Project Location:	0 Mandela Parkway. The vacant parcel is located across from the neighboring property at 3650 Mandela Parkway and next to Beach Street and Target store.
Assessor's Parcel No:	007 061701405
Development Proposal:	To construct a six-story building "Mandela Hotel" consisting of 220 rooms measuring approximately 142,813 square feet of floor area with two-levels of underground parking garage and a small open parking area totaling 166 parking spaces.
Project Applicant / Phone Number:	Joanne Park, lead architect for Architectural Dimensions / (510) 463-8300
Hotel Operators:	Tulsee Nathu & Payal Nathu
Property Owner:	State of California
Case File Number:	PLN16394
Planning Permits Required:	<ol style="list-style-type: none"> 1) Major Conditional Use Permit for non-residential projects with more than 25,000 square feet of floor area; 2) Minor Conditional Use Permits for transient habitation (Hotels) and non-residential tandem parking; 3) Regular Design Review for new building construction; and 4) Minor Variance for front yard setback reduction.

CITY OF OAKLAND PLANNING COMMISSION

Case File: PLN16394

Date: March 20, 2018
To: Mike Rivera, Project Case Planner
From: Sharon Wr

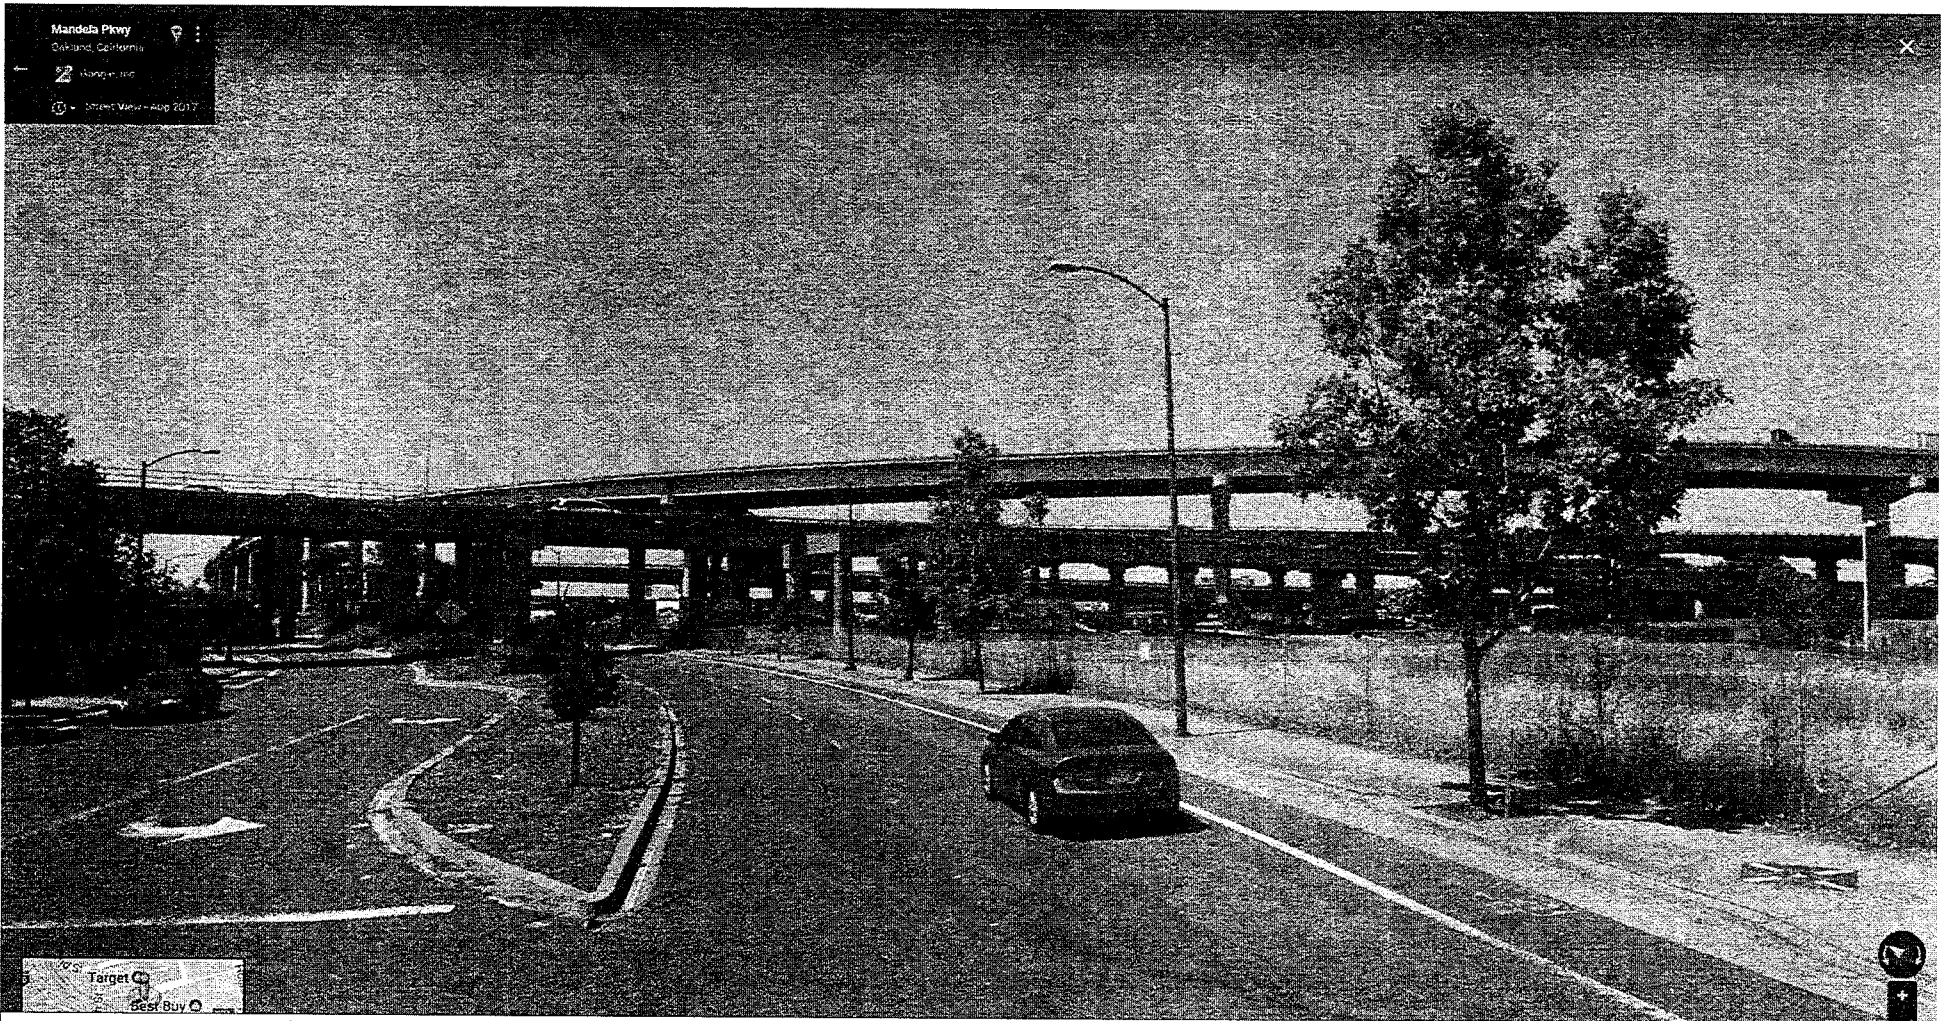
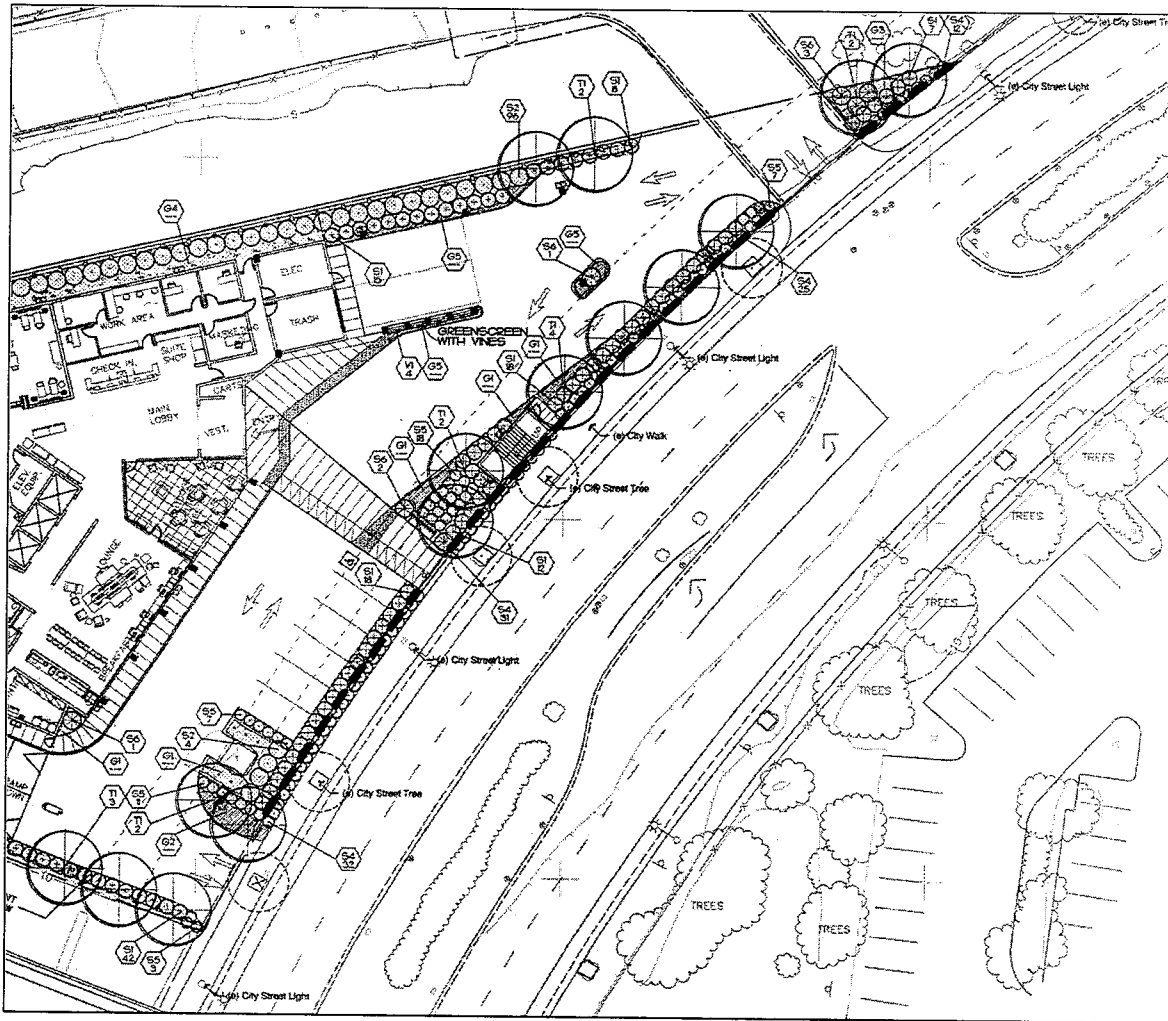
- **MACRO ISSUE:** Existing poor condition of the public realm of this segment of Mandela Parkway on both the frontage sidewalk and the median will not reflect well on the quality of the hotel. Both the hotel and the community will benefit in terms of image and pedestrian amenity from improved plantings and maintenance on both sidewalk AND median if installed as a condition of approval, given that the existing maintenance funding along Mandela Parkway are unable to keep up with maintenance (e.g. see the conditions of existing median landscaping, existing drinking fountains, trash receptacles, dog bag dispensers, etc.).

- The proposed decorative metal fence is a good idea and its proposed design is very attractive.
- Please ensure that across the width of where the main entrance walkway meets the Mandela Parkway sidewalk, **there is NO fence to block that pathway.** A blocked entrance defeats the whole concept of a welcoming public Mandela Parkway entrance.
- *Please ensure that all extents of frontages along Mandela are fenced to avoid trash and dumping that is unfortunately prevalent in this area.*
